<b>Wulfsberg Electronics</b> <i>A Chelton Group Company</i>			
<b>APPROVALS</b>		<b>DATE</b>		<b>TITLE:</b> <b>SERVICE BULLETIN WSB IDU-III-19</b> <b>(RAM REPLACEMENT)</b>	
DRAWN	Robert DuRall	3/11/06			
CHECKED	Dean Boston	3/11/06			
PRODUCT MANAGER					
ENGINEER	Rober DuRall	3/11/06		SIZE	CAGE CODE
ISSUED	Diana Woodhurst	3/21/06		<b>A</b>	<b>1B7G3</b>
<b>Typed signatures indicate approval. Handwritten signature approval of this document is on file at Wulfsberg Electronics, Prescott, Arizona.</b>		SCALE: NONE		DWG NO. <b>150-045039</b>	
				REV <b>A</b>	
				DO NOT SCALE DRAWING

## SERVICE BULLETIN

**EQUIPMENT:** IDU-III

**INSTRUCTION NUMBER:** WSB IDU-III-19 Revision A

**Figure 4 RAM Removal**

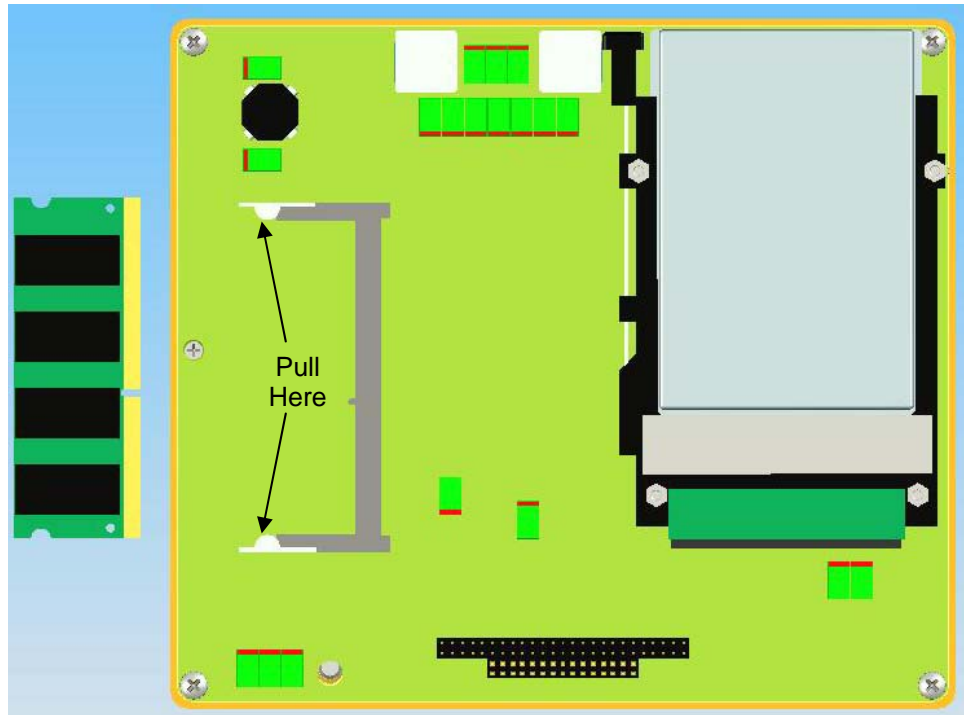
4. Locate and remove the 64MB RAM module from the SO-DIMM connector on the CPU board by gently pulling the locking tabs apart allowing the RAM assembly to rotate away from the CPU board as shown in Figure 4.

**Figure 5 RAM Insertion**

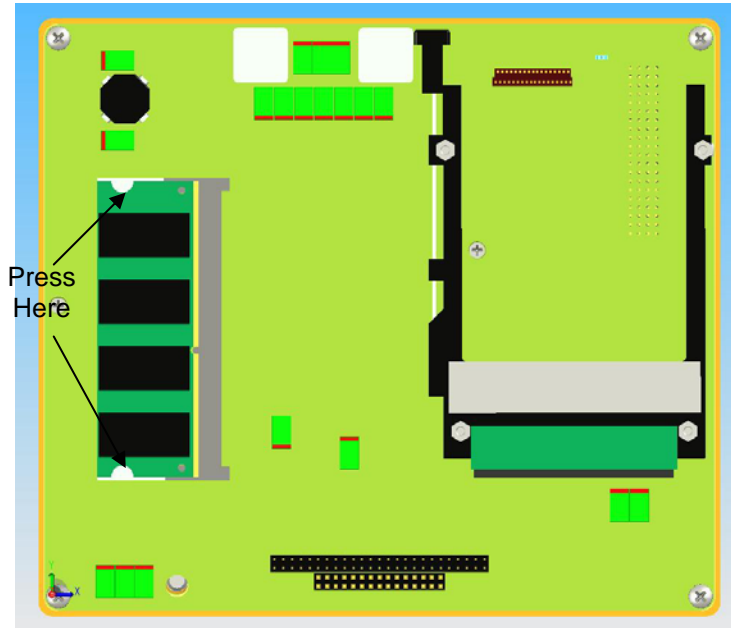
5. Grasp the RAM module and pull away from the CPU board.
6. Install the new 128MB RAM (Item 1) into the SO-DIMM connector ensuring the locator slot on the RAM module mates with the locator ridge on the connector.
7. Push down on the RAM module until the connector locking tabs seat the module into the connector.

8. Ensure the module mates with the connector by gently pressing the locking tabs together as shown in Figure 5.

**Figure 6 ID Label Marking**

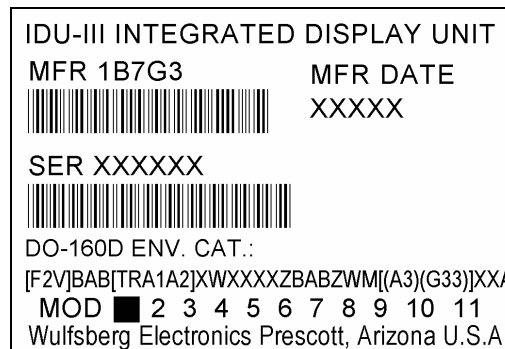
9. Assemble the bezel and display assembly removed in step 3 onto the CPU board assembly. Ensure the pins on the bezel and display assembly properly mate to the J3 and J4 connectors on the CPU board.
10. Place the top and bottom enclosures removed in step 2 over the assembly.
11. Apply a light coating of 222 Loctite<sup>®</sup> onto the threads and attach (16) 4-40 x 3/16" screws removed in step 1.
12. Attach (2) Warranty seals (Item 2) onto the sides of the IDU. Ensure one screw on the top and bottom enclosures is completely covered with the seal on each side.
13. Mark out MOD "1" on the IDU-III ID Label using indelible ink (Item 3) as shown in Figure 6.
